Addendum No. 1

Re: Part B - James M. Seals, JR. Park – Athletic Restroom/ Concession and Field Improvements
504 Texas Street, Mobile, AL 36603
Project No. PR-041-20
Part C - Hackmeyer Park – Improvements Phase 2
3810 Conway Drive South, Mobile, AL 36608
Project No. PR-034-21

Date: November 14, 2022

SCALE: NOT TO SCALE

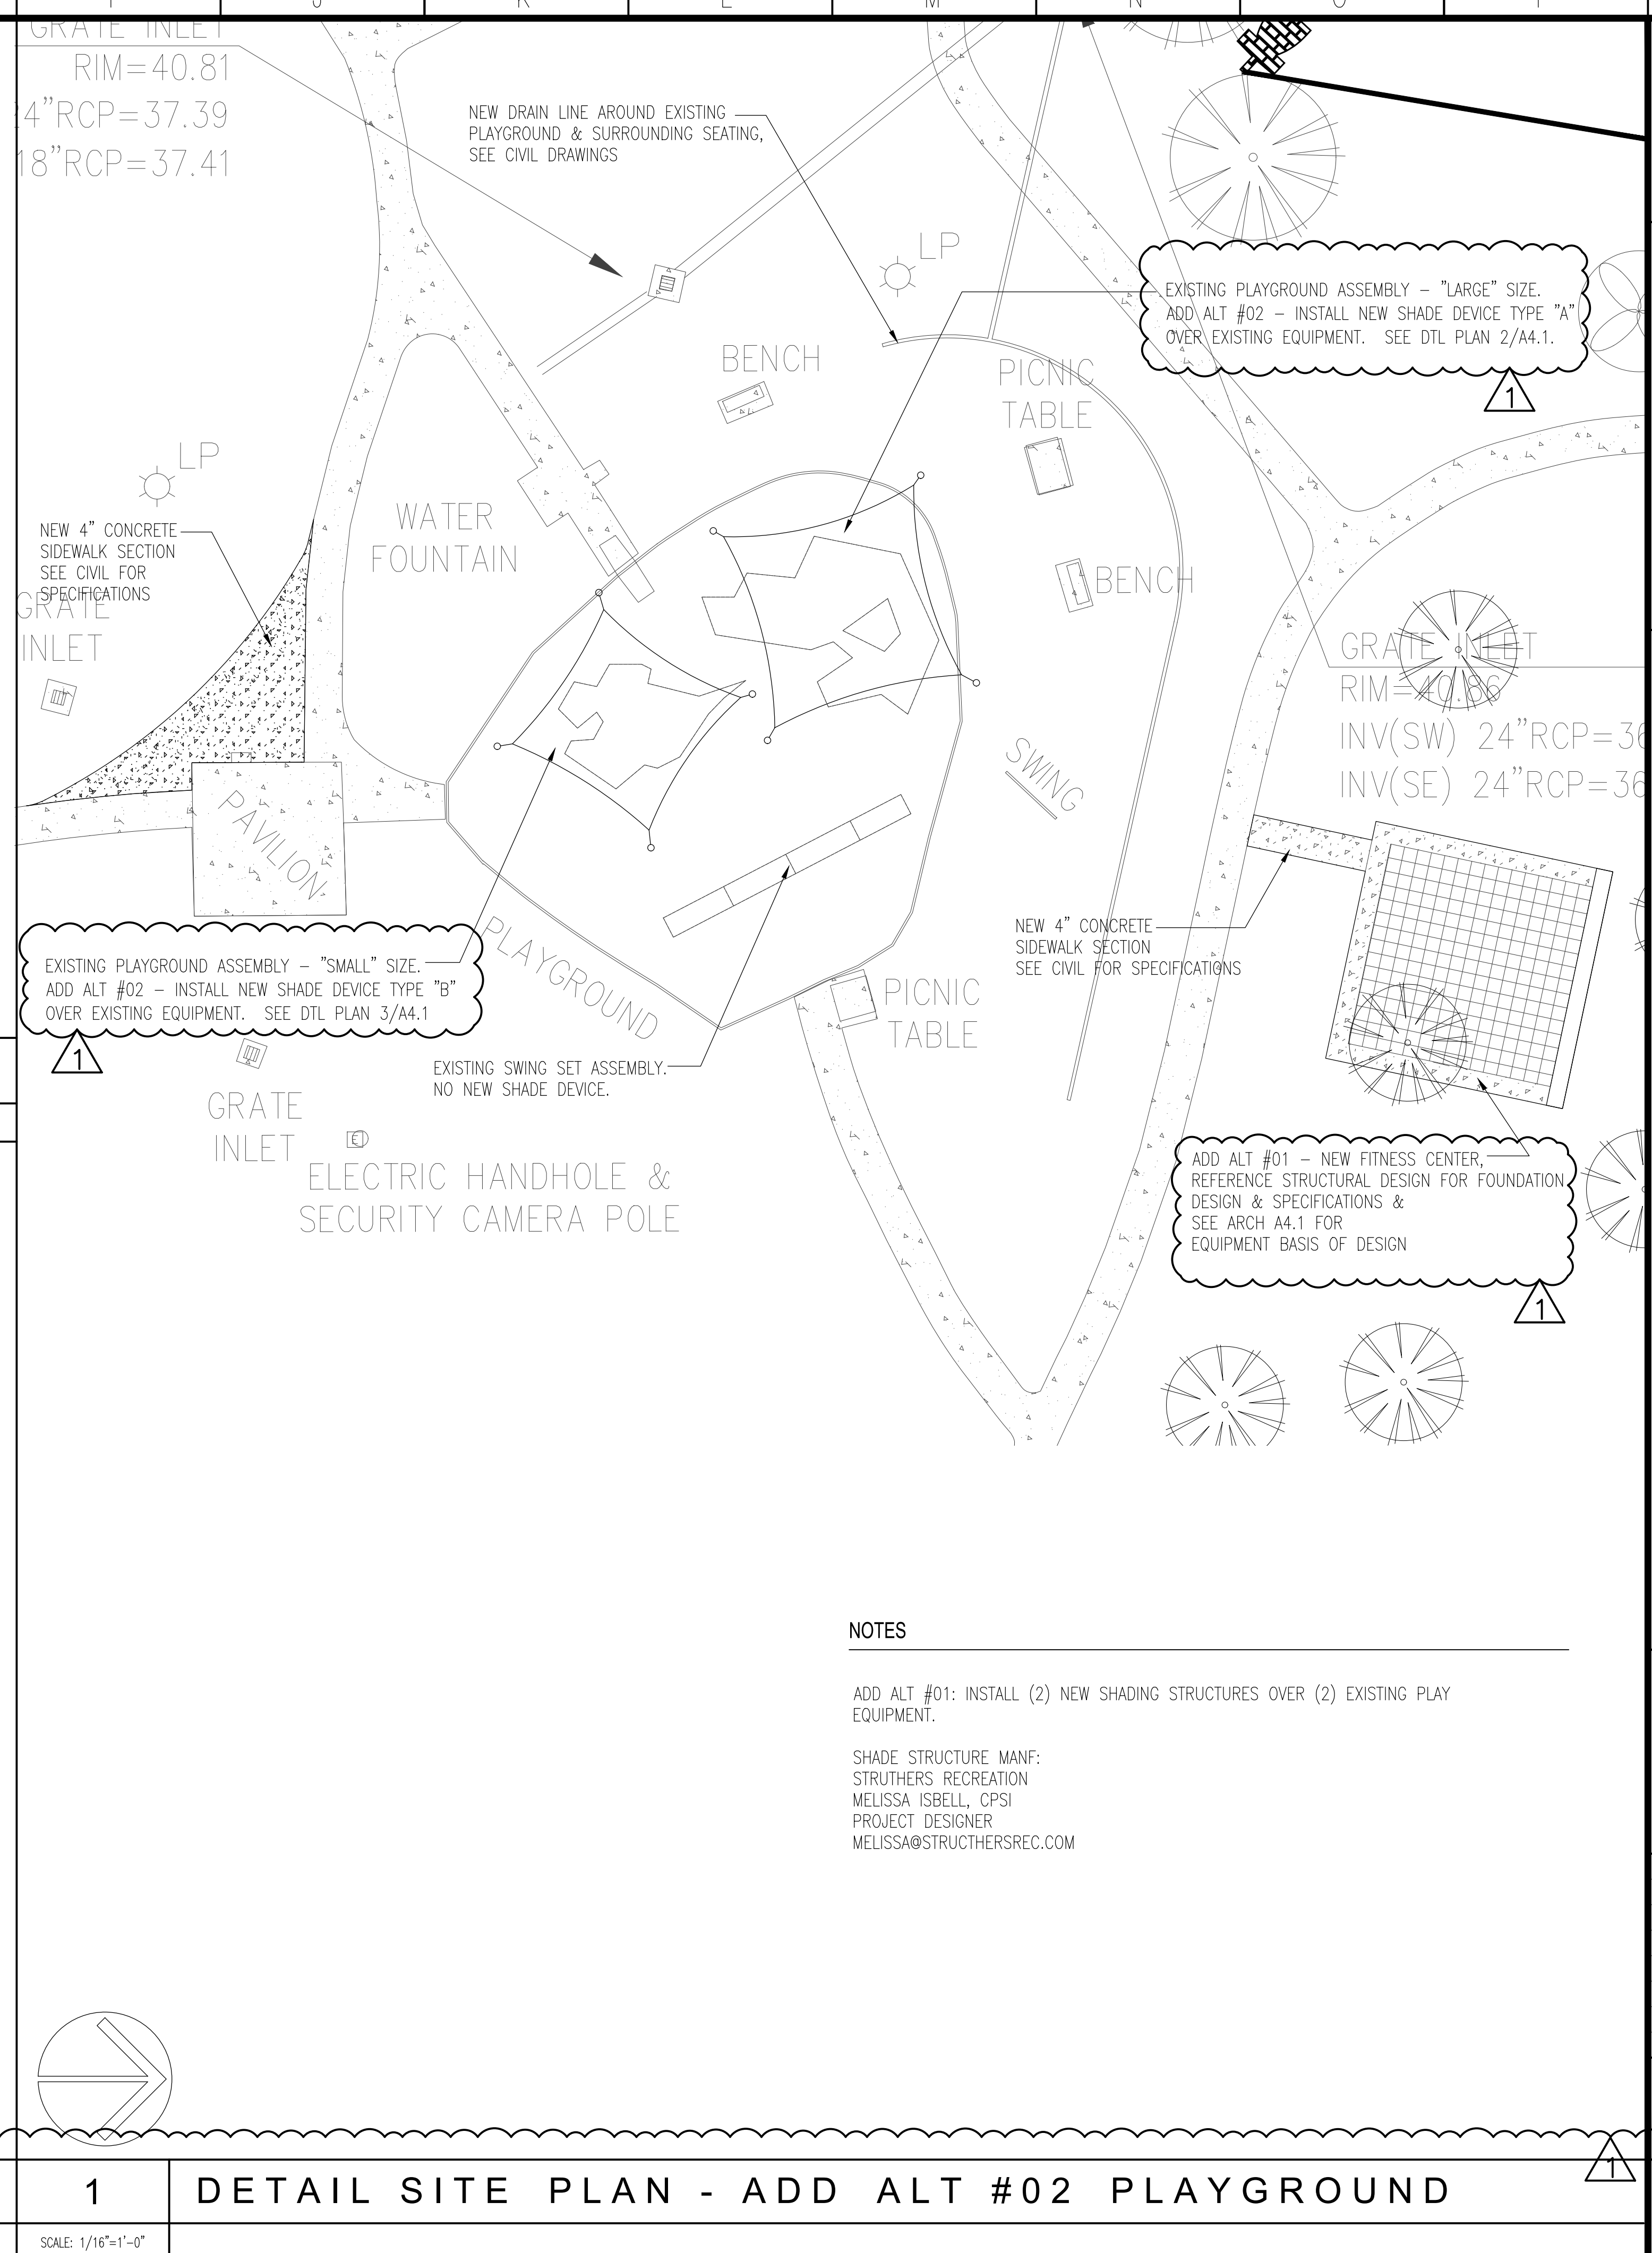
- Item 7: Sheet A4.2 Playground Shading Devices

Replace this sheet dated 11.02.22 with the attached revised sheet of same title A4.1, dated November 07, 2022 and labeled Revision 01 (Addendum No. 1). Substantial changes include the following:

Revise Add Alternate # - Change Shading Devices from Add Alt #1 to Add Alt #2
